RECOMMENDED SERVICE BULLETIN

RSB 42-125

RSB 42NG-065

Replacement of steel pin of door handle mechanism of canopy and passenger door with an improved design.

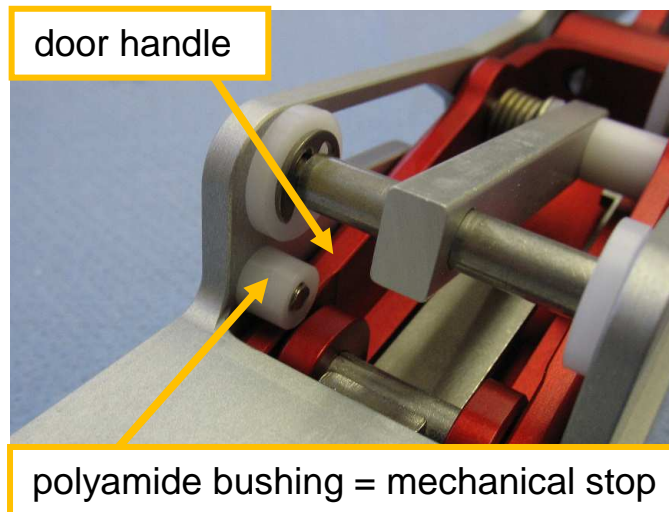
Adjust the length of the compression gas spring. Make sure that the polyamide bushing defines the mechanical stop of the red aluminum door handle as shown in the picture below.

Note: The mechanical stop of the red aluminum door handle must not be defined by the internal stop of the compression gas spring.

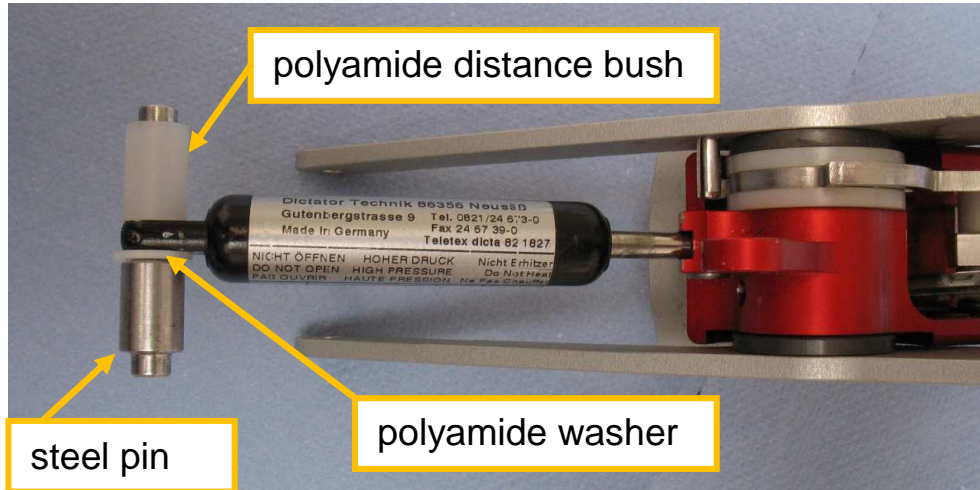
Prepare the new steel pin for installation into the door handle mechanism frame:

- Move the polyamide washer onto the new steel pin.
- Move the steel pin through the eye end of the compression gas spring.
- Move the polyamide distance bush onto the steel pin.

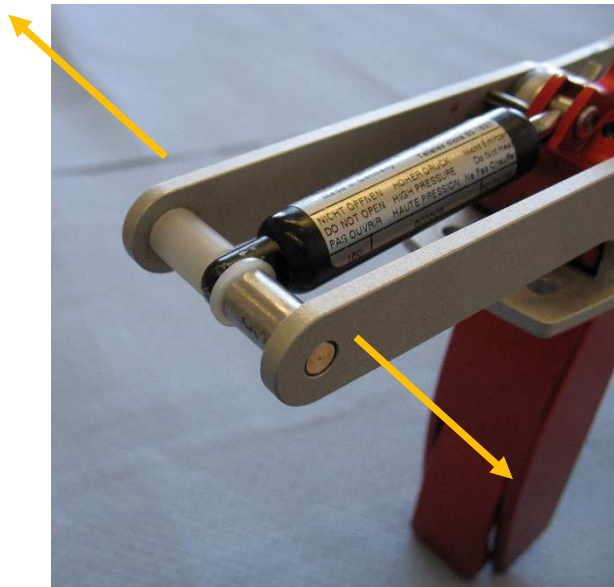
Install the new steel pin with the polyamide washer and the polyamide distance bush to the door handle mechanism frame:

- Move the steel pin into position.
- Carefully bend the side parts of the door handle mechanism frame away from each other as shown by the yellow arrows in the picture below so that the steel pin can snap into the holes of the side parts of the door handle mechanism frame.

Caution: Bend the side parts of the door handle mechanism frame away from each other only as far as necessary. If the side parts are bent too much and permanently deformed, the whole door handle mechanism must be replaced.
